**Addendum No. 2**

**Subject:** JOSEPH PENNELL ELEMENTARY SCHOOL  
FIRE ALARM REPLACEMENT  
SDP CONTRACT NO. B-001C OF 2017/2018

**Location:** JOSEPH PENNELL ELEMENTARY SCHOOL  
1800 WEST NEDRO AVENUE  
PHILADELPHIA, PA 19141

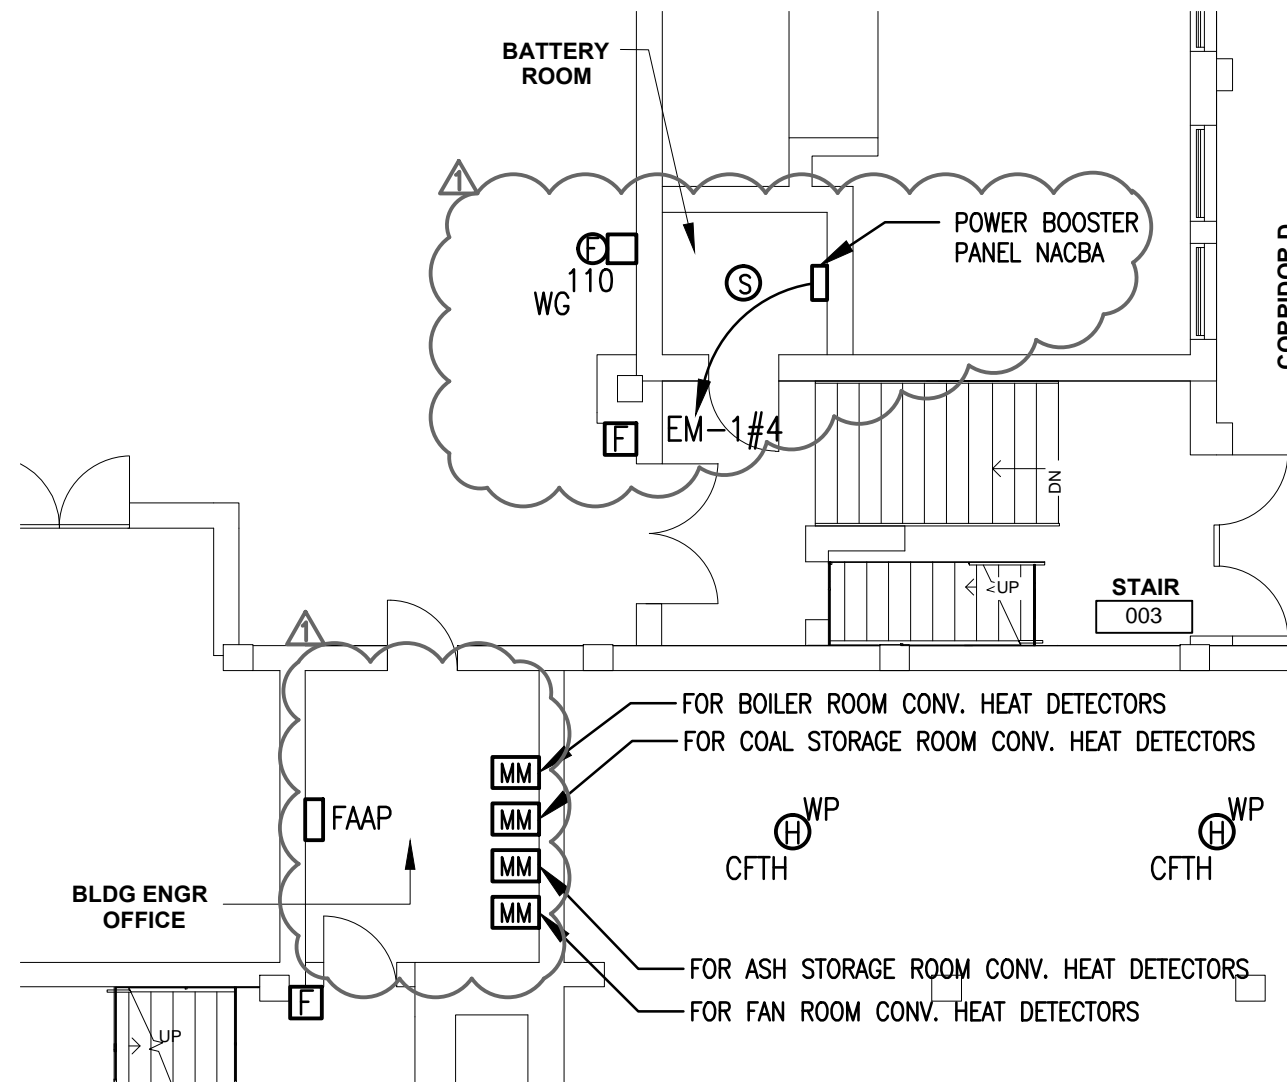
- 1.1. E000: See attached sketch ECKS-1.
- 1.2. E100.1: See attached sketch ECKS-2.
- 1.3. E100.2: See attached sketch ECKS-3.
- 1.4. E101: See attached sketch ECKS-4.

12. FIRE ALARM SYSTEM RISER SHOWN ON THIS DRAWING IS TYPICAL ONLY & IT MAY NOT INDICATE ALL PERIPHERAL DEVICES; REFER TO THE PLANS FOR LOCATIONS & QUANTITIES OF THE ALL PERIPHERAL DEVICES. PLANS & FIRE ALARM SYSTEM RISER MAY NOT INDICATE ALL REQUIRED POWER BOOSTER PANELS; SUPPLIER SHALL PROVIDE ALL REQUIRED POWER BOOSTER PANELS FOR THE COMPLETE SYSTEM & THE CONTRACTOR SHALL INSTALL & WIRE ALL POWER BOOSTER PANEL FOR THE COMPLETE SYSTEM.

13. CONTRACTOR SHALL PROVIDE THE FOLLOWING SPARE EQUIPMENT/DEVICES TO FURNISH & INSTALL AT ADDITIONAL LOCATIONS IF REQUESTED BY OWNER. CONTRACTOR SHALL INCLUDE THE COST OF INSTALLATION & WIRING FOR ALL SPARE DEVICES/EQUIPMENT IN THE BASE BID.

- A. (15) SMOKE DETECTORS
- B. (5) HEAT DETECTORS, ADDRESSABLE COMBINATION TYPE
- C. (2) HEAT DETECTORS, CONVENTIONAL COMBINATION TYPE (FOR HIGH CEILING AREAS)
- D. (1) HEAT DETECTORS, CONVENTIONAL TYPE FIXED HIGH TEMPERATURE SENSOR TYPE 190F DEGREE RATED
- E. (5) MANUAL PULL STATIONS W/ PROTECTIVE COVER & ALARM
- F. (5) COMBINATION HORN/STROBE NOTIFICATION DEVICES
- G. (5) VISUAL STROBE NOTIFICATION DEVICES
- H. (3) WEATHERPROOF HEAT DETECTORS, CONVENTIONAL TYPE FIXED TEMPERATURE
